Customer :	CU-DAR001 Dart Helicopters Services	Drawing Name :	350 SKIDTUBE ASSEMBLY LH
Job Number :	40696	Part Number :	D350636011
Estimate Number :	10262	Drawing Number :	D2750 UNDER REVIEW
P.O. Number :		Project Number :	N/A
This Issue :	22/07/2008	Drawing Revision :	UPDATE PER DSI 9413
Prsht Rev. :	NC	Material :	
First Issue :	11	Due Date :	10/08/2008
Previous Run :	39972	Qty:	1 Um: Each
Written By :			
Checked & Approved By :	JUD 08.722		
Comment :	Est Rev: I 02.09.25 Rearranged procedure steps KJ Est Rev: J 06-03-23 As per Rev D JLM Est Rev: K 06-07.13 As per dsi9343 EC Est Rev: L 07-07-28 Added SS Wearplates (Rev E) JLM Verified By: EC Est Rev: M 08-04-22 update steps 4, 13 DD verified by: EC

DART SERVICE INSTRUCTION

THE WEARPLATES ON D350-636-011/-012/-013/-014 SKIDTUBES AT CHG 004 (AND LATER) HAVE BEEN MODIFIED AS SHOWN IN FIGURE 1 BELOW TO ELIMINATE THE POSSIBILITY OF INTERFERENCE BETWEEN THE WEARPLATES AND CROSSTUBE SADDLES AT INSTALLATION. THERE IS NEGLIGIBLE WEIGHT CHANGE ASSOCIATED WITH THIS MODIFICATION.

A	NEW ISSUE	PH	08.05.14
REV.	DESCRIPTION	BY	DATE
DESIGN	PH	DART AEROSPACE USA, INC PORT HADLOCK, WA	
DRAWN	PH		
CHECKED		DRAWING NO.	REV. A
MFG. APPR.	N/A	DSI 9413

FIGURE 1 - WEARPLATE MODIFICATION

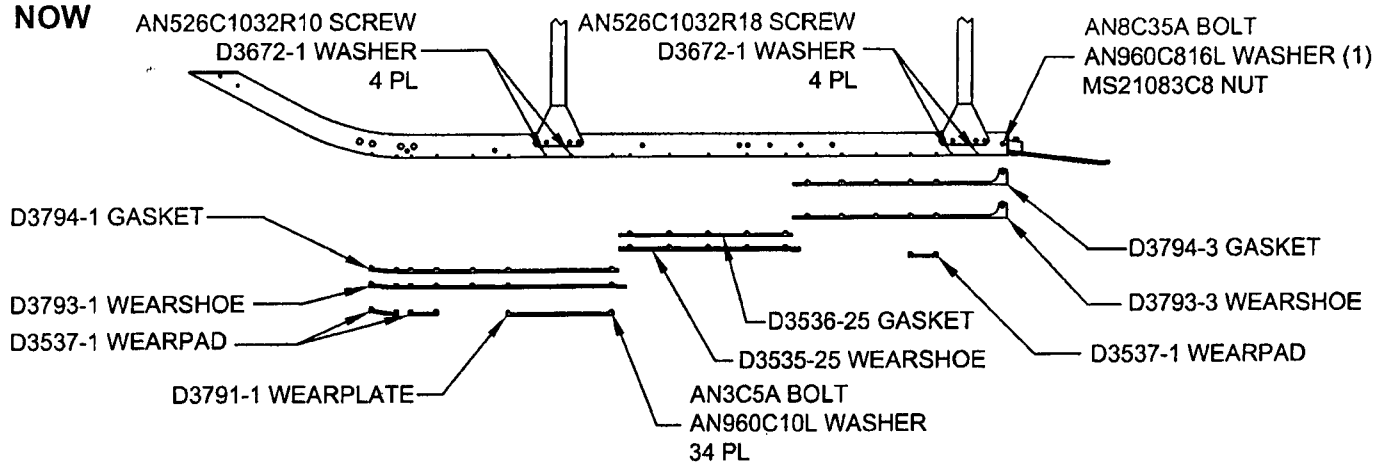
(AN526C1032RXX SCREW LOCATIONS NO LONGER USED TO MOUNT WEARSHOES)

TO INSTALL THE DSI 9413-011 KIT, REMOVE THE EXISTING WEARSHOES/GASKETS UNDER THE FWD/AFT SADDLES AND INSTALL NEW WEARSHOES/GASKETS AS SHOWN IN FIGURE 1. PLUG UNUSED HOLES WITH AN526C1032RXX SCREWS AND D3672-1 WASHERS. INSTALL SCREWS WITH SIKAFLEX -241/-291 OR PROSEAL 890 OR MIL-S-8802 CLASS 'B2' SEALANT AS SHOWN IN FIGURE 1. NOTE: SOME OF THE PREVIOUSLY INSTALLED HARDWARE IS NO LONGER REQUIRED.
